TECHNICAL BULLETIN

New Improvements to HAPP CONTROLS Optical Guns Increase Strength and Reliability

OPTICAL GUN HALVES UPDATE KIT

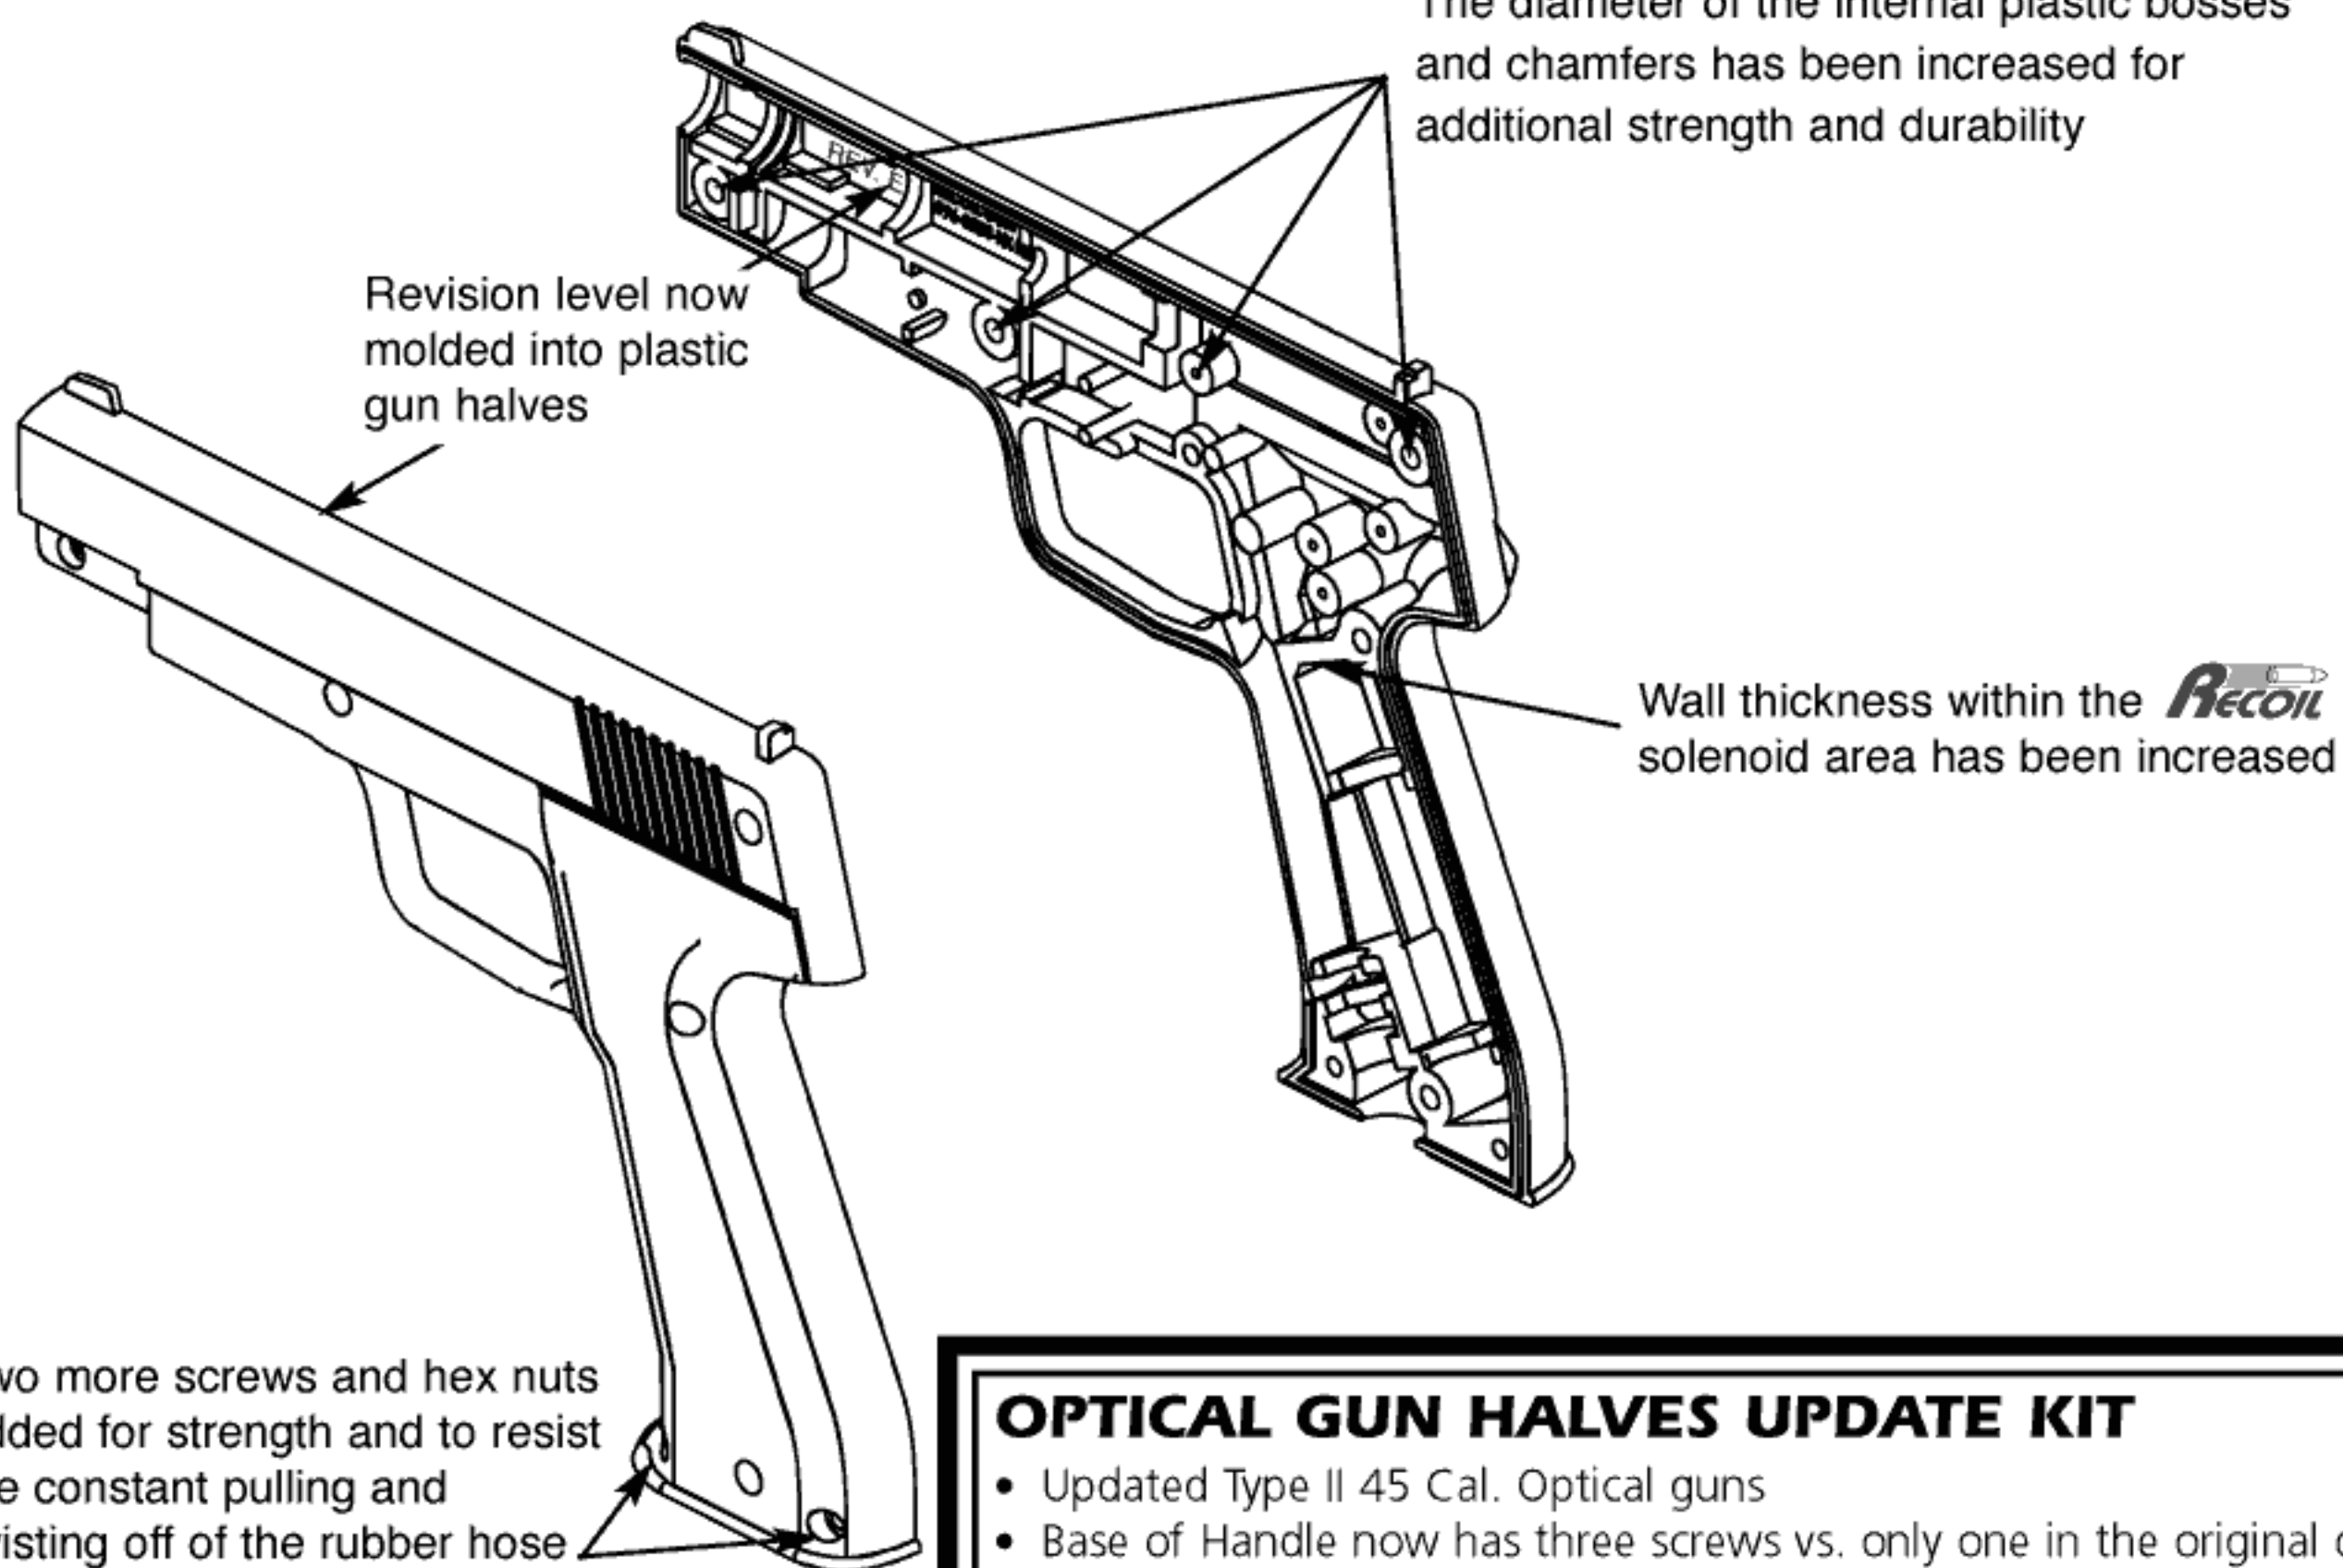
- We have added two more screws and hex nuts to the bottom of the gun handle. The original design had one screw, the updated version provides three. This change assures more strength to resist breaking in this area due to the constant pulling and twisting of the rubber hose.
- The diameter of the internal plastic bosses and chamfers has been increased for additional strength and durability.
- The plastic wall thickness within the *Recoil* solenoid area has been increased for improved strength.
- The new improved version is identified by Revision "E" or higher. You can find this molded on the inside of the plastic gun halves.

- Updated Type II 45 Cal. Optical guns
- Base of Handle now has three screws vs. only one in the original design
- The diameter of the internal bosses and chamfers has been increased for increased strength and durability
- The Wall thickness within the "recoil" solenoid area has been increased for improved strength
- The new improved version is identified by Revision "E" or higher. You can find this molded on the inside of the plastic gun halves
- Will not work with older Type I rubber hoses
- Kit contains the following items
 - Left plastic gun half (Revised Type II) 96-0286-XX
 - Right plastic gun half (Revised Type II) 96-0285-XX
 - Gun handle screws (5) 43-0095-00
 - Gun handle screws (2) 43-0336-00
 - Gun handle nuts (2) 43-0094-00
